DPC-NE-2005A, Revision 3

Duke Power Company
Thermal-Hydraulic
Statistical Core
Design Methodology

SUBJECT: CATAWBA NUCLEAR STATION, UNITS 1 AND 2 AND MCGUIRE NUCLEAR STATION, UNITS 1 AND 2 RE: ACCEPTANCE FOR REFERENCING OF THE MODIFIED LICENSING TOPICAL REPORT, DPC-NE-2005P (TAC NOS. MB3105, MB3106, MB3173, AND MB3175)

Enclosure: Safety Evaluation

FIGURE 2
REVISED SCD FLOWCHART

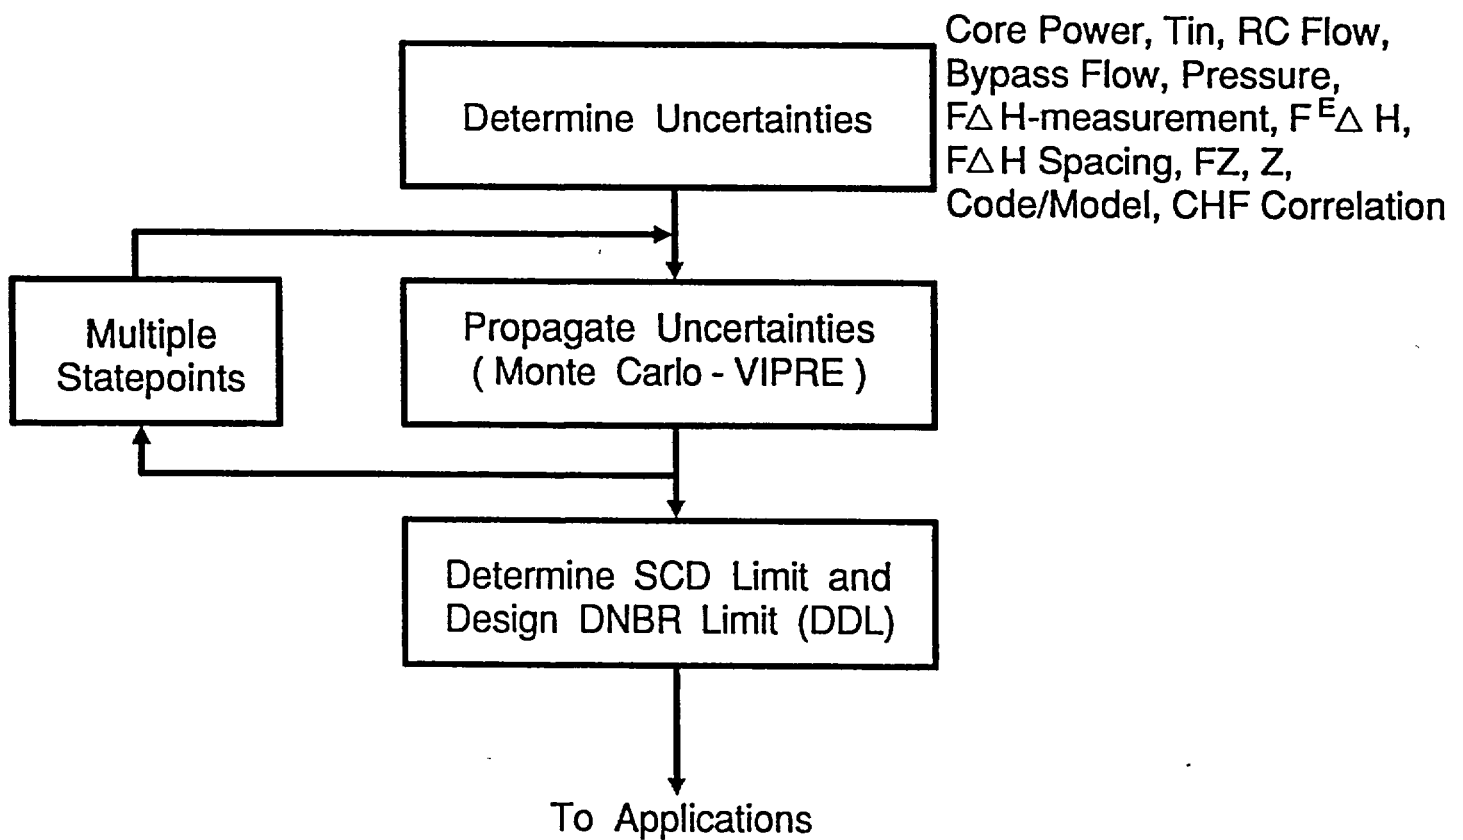
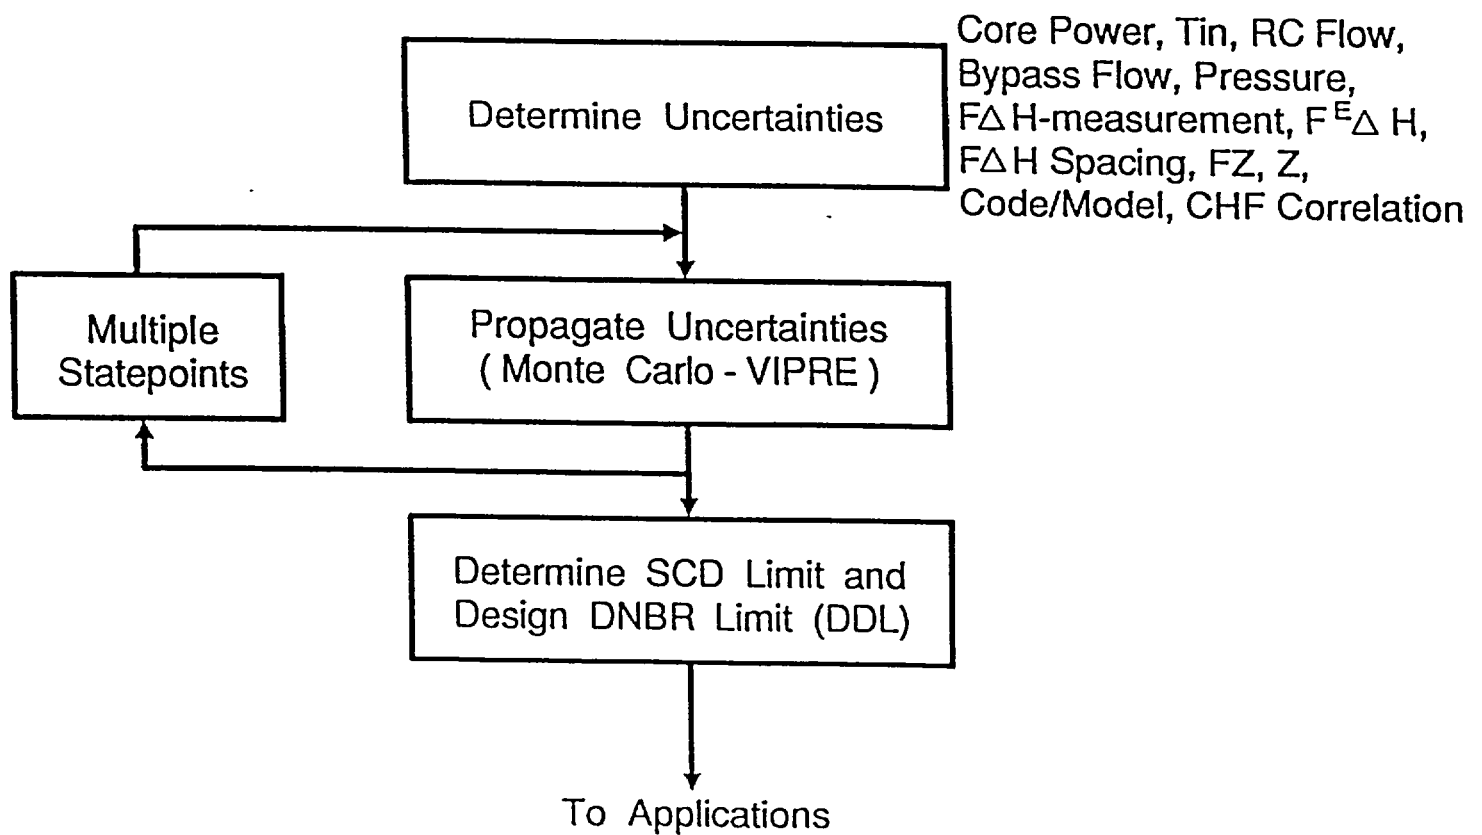
Additionally, the flow chart in Figure 2 also contains a typo. The Propagate Uncertainties box should have the words (Monte Carlo - VIPRE) underneath. The RSM is not used at all in the revised method described by the report. A corrected page 30 is also included.
